**CITY OF MILL CREEK
DESIGN REVIEW BOARD
APPLICATION PL2019-0010**

NAME OF PROJECT: Creekside Phase II

PROPOSAL: Review of building elevations and landscaping.

Drawing:	A3.1
Job Number:	18c-4026

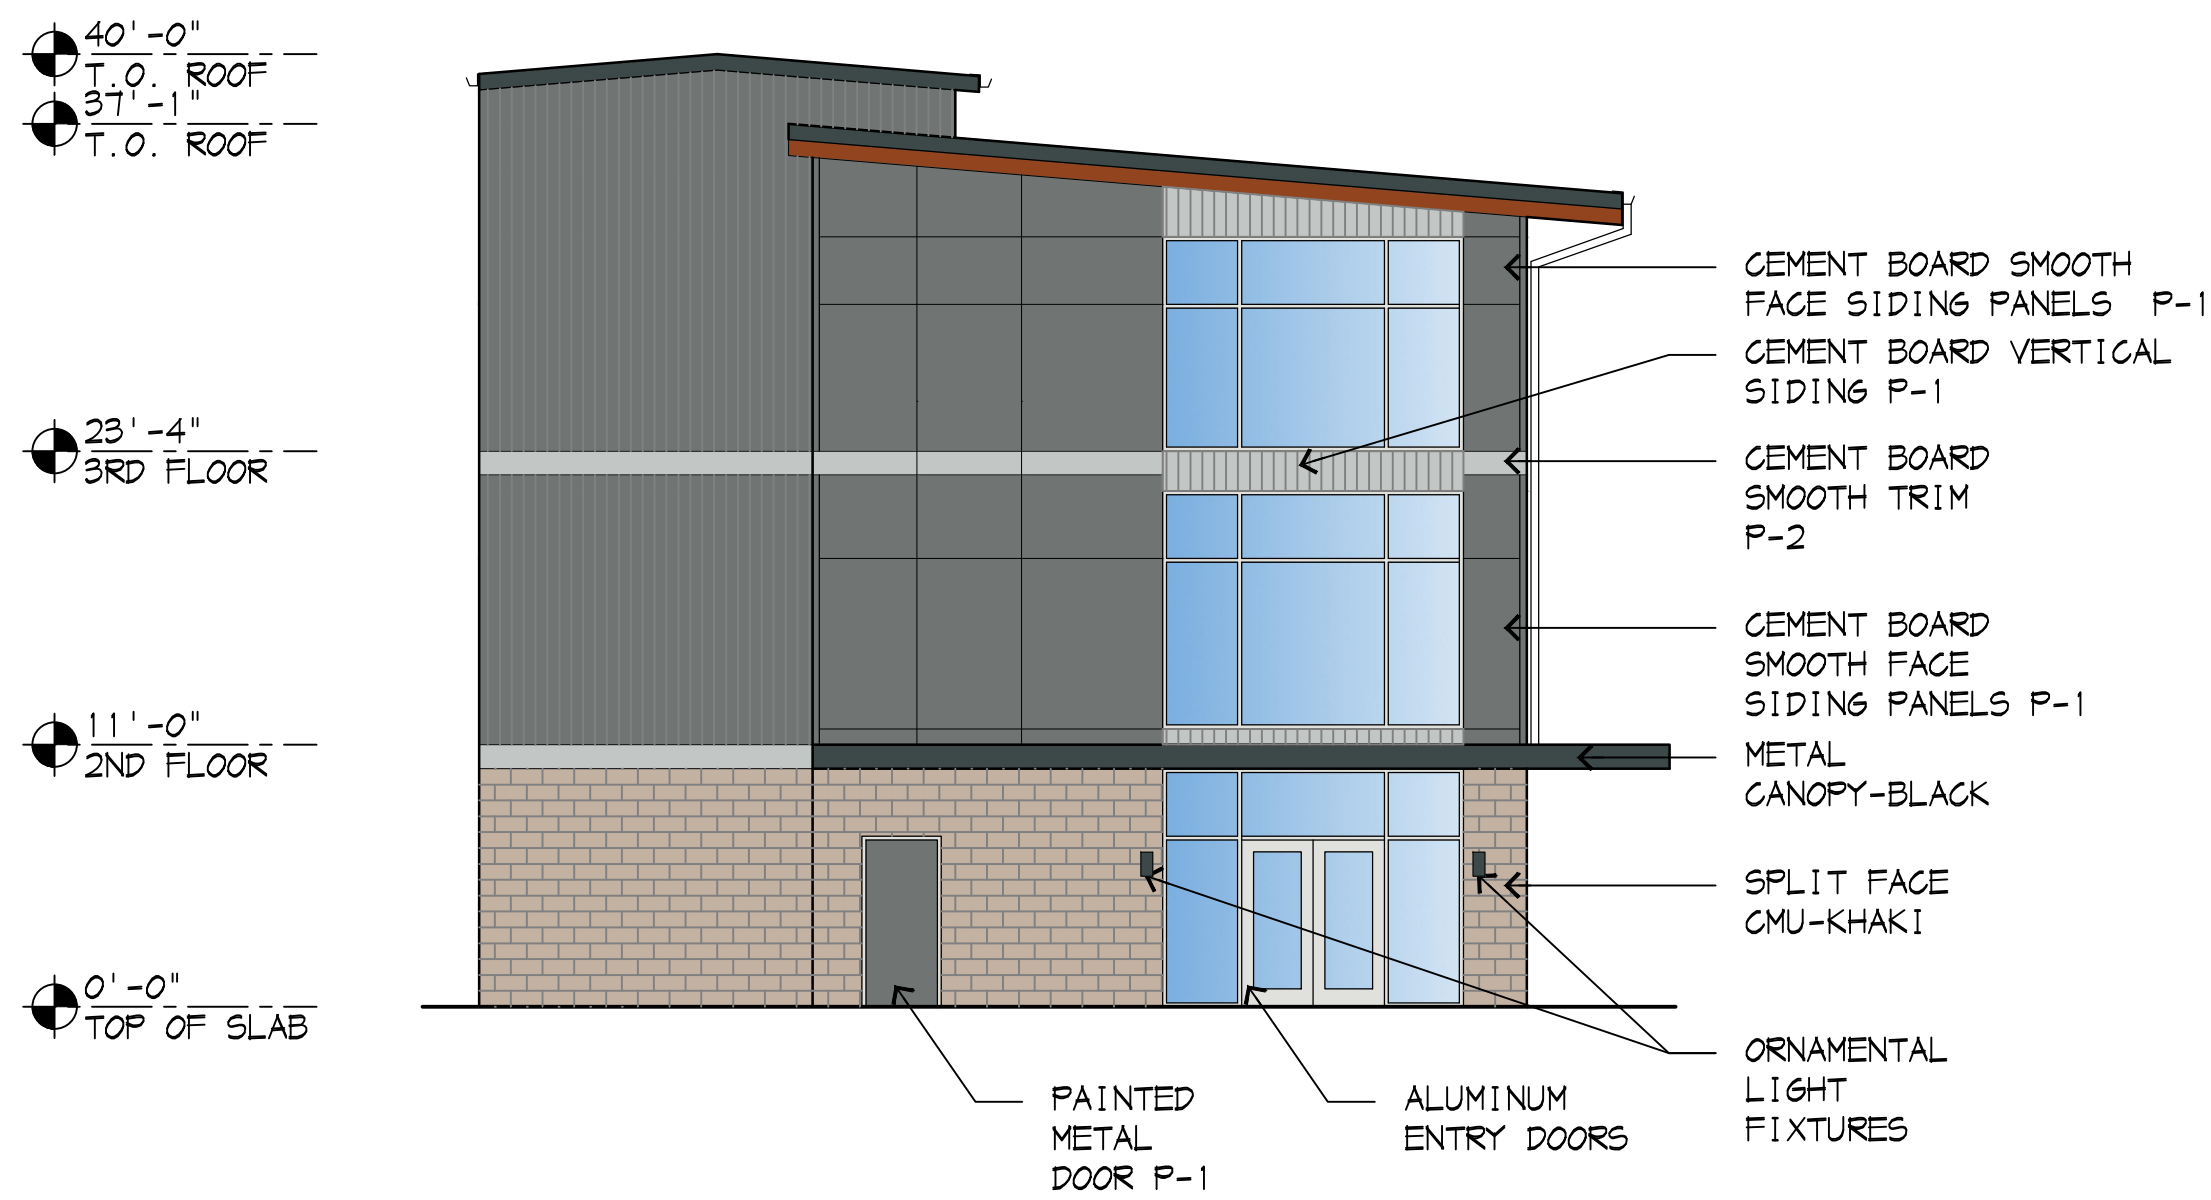
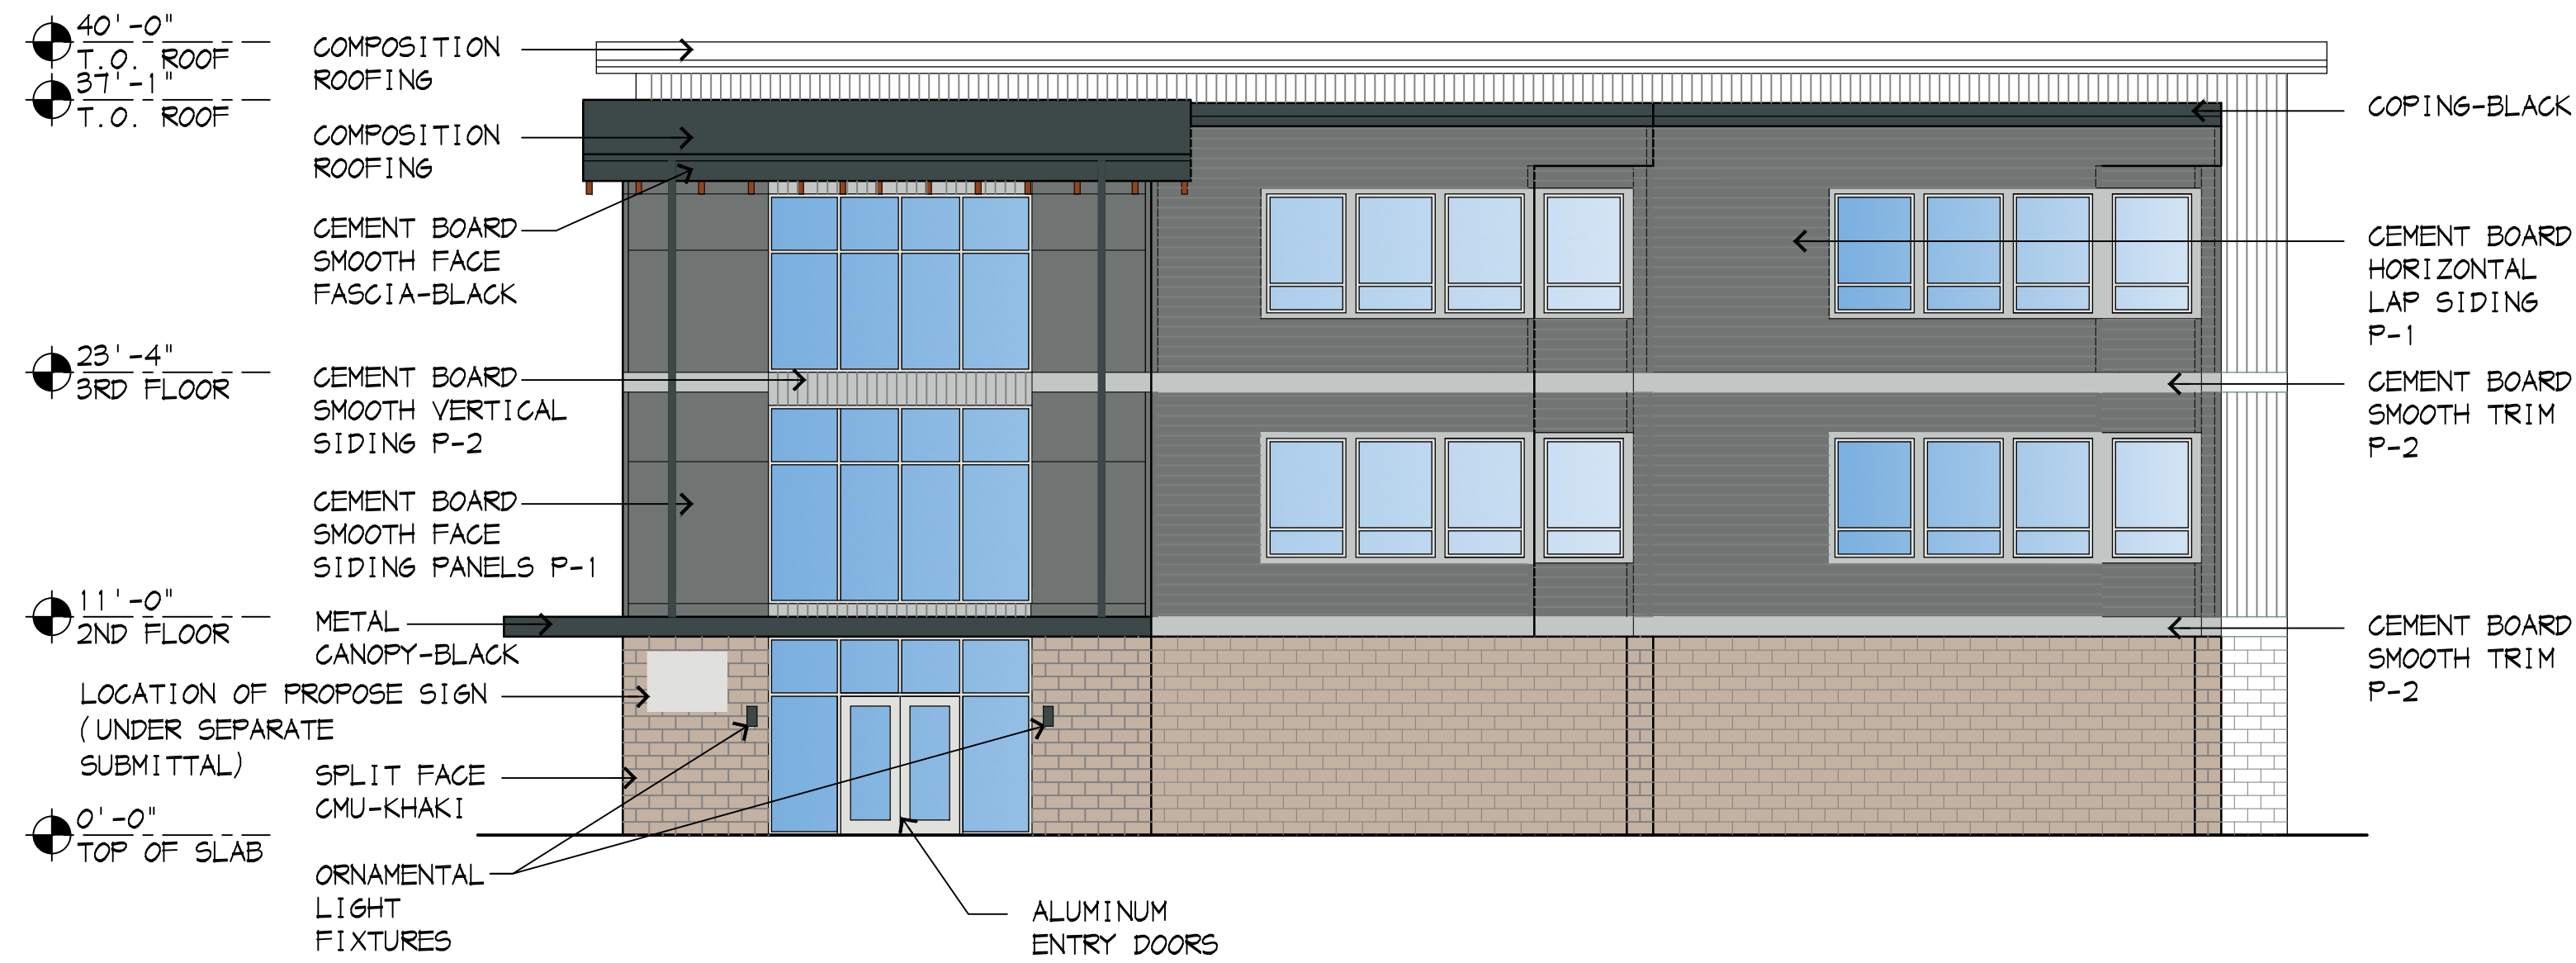
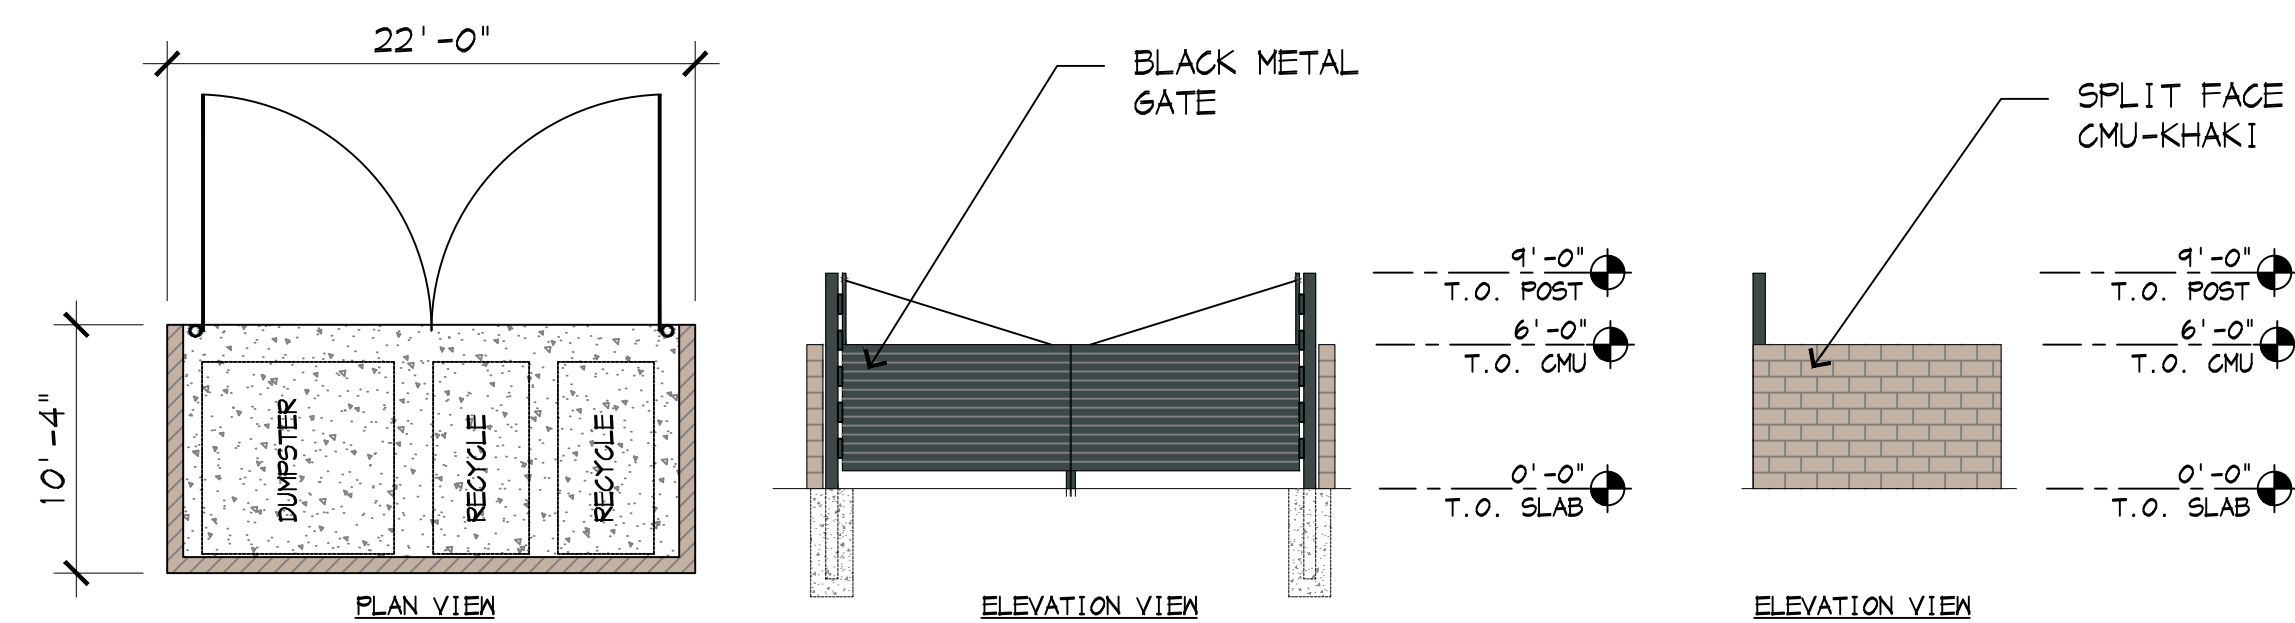
The proposed building exterior materials include a combination of cement board in smooth, horizontal lap siding and vertical siding all in a medium gray color identified as Sherwin Williams Software 7074 and smooth trim and vertical siding in light gray identified as Sherwin Williams Gray Screen 7071. The ground floor is anchored with split face CMU in Khaki. The building materials have been selected to coordinate with the existing office building (Creskide Phase I) located across the parking lot at 16504 9th Avenue Southeast (**See attached photos**). Building modulation has been incorporated to ensure that no exterior wall will be longer than 50 feet without an offset or setback. To avoid blank walls, the architect has chosen to use a masonry base, belt course of a different color, variation in the texture of the cement board siding, windows – in particular the large windows highlighting the entry, and a projecting black metal canopy over the entry doors.

The trash enclosure is located in the southwest corner and is proposed to be constructed of split face CMU in Khaki and have a solid, black metal gate. The mechanical equipment, located on the western elevation, will be ground mounted and screened by a horizontal cedar fence painted in the dark gray to coordinate with the building. (See *Attached Project Narrative, Color Elevations -- Sheet A-3.1, and Floor Plans -- Sheet A2.1*)

Staff believes that the building elevations comply with the intent of the design guidelines contained in the Code and is recommending approval as proposed.
